Subject: F18D059 Self Storage building addition 5310 San Mateo TCL Comments

DRAINAGE AND TRANSPORTATION INFORMATION SHEET (REV 09/2015)

Project Title: SELF STORAGE BUILDING ADDITION	Building Permit #:	City Drainage #: F180059
DRB#: EPC#:	_	Work Order#:
Legal Description: TRACT B LANDS OF HUDSON AND HUDSON		
City Address: 5220 AND 5310 SAN MATEO BLVD NE - ALBUQUERQUE NM 8710	09	
Engineering Firm:		Contact:
Address:		Contact:
		E-mail:
Address: 5854 OSUNA ROAD NE ALBUQUERQUE NM 87109		
Phone#: 505 883 7373 Fax#:		E-mail:
Architect: ROBERT MAZE		Contact: ROBERT MAZE
Address: 3400 ALVARADO DR NE ALBUQUERQUE NM 87110		
Phone#: 505 884 3304 Fax#:		E-mail: BOB@DESERT-SKY-DESIGNS.COM
Other Contact:		Contact:
Address:		
Phone#: Fax#:		E-mail:
DEPARTMENT: HYDROLOGY/ DRAINAGE ×TRAFFIC/ TRANSPORTATION MS4/ EROSION & SEDIMENT CONTROL	X BUILDING P	APPROVAL/ACCEPTANCE SOUGHT: ERMIT APPROVAL E OF OCCUPANCY
TYPE OF SUBMITTAL:		
ENCINEED / A DOUTECT, CEDITIES ATION		RY PLAT APPROVAL
ENGINEER ARCHITECT CERTIFICATION		FOR SUB'D APPROVAL
CONCEPTUAL G & D PLAN	SITE PLAN I	FOR BLDG. PERMIT APPROVAL

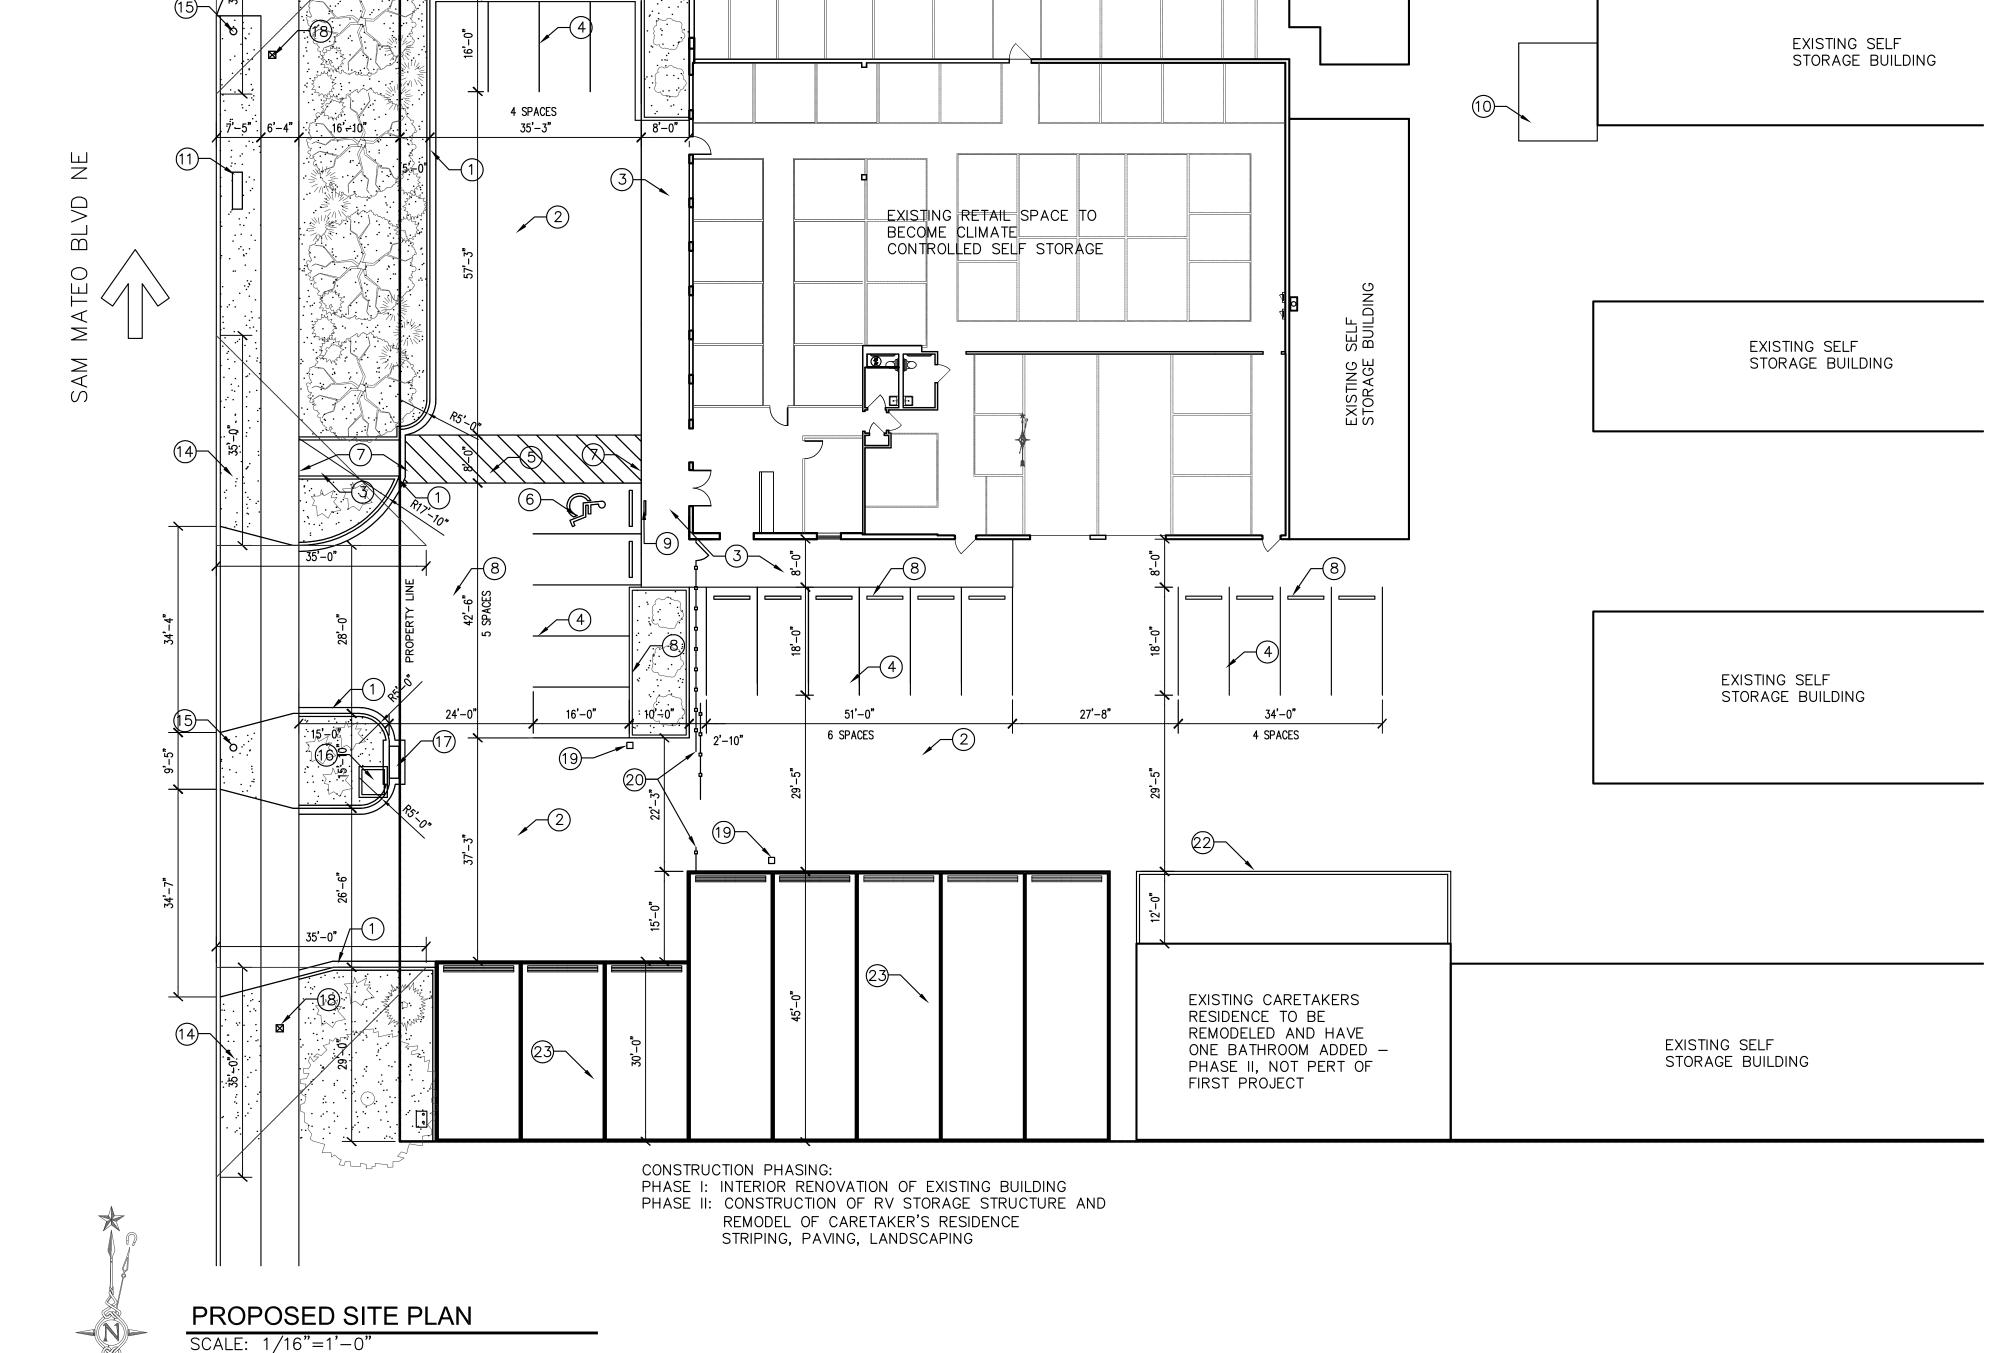
- Addressing the ADA in the notes is ok. I would like to see them in the Key Notes too.
- If you can show the words "No Parking" on the plan view in the proper location it will help the contractor.
- One of the Driveways on the San Mateo should be closed as well. You can make the remaining drive wider if you need.
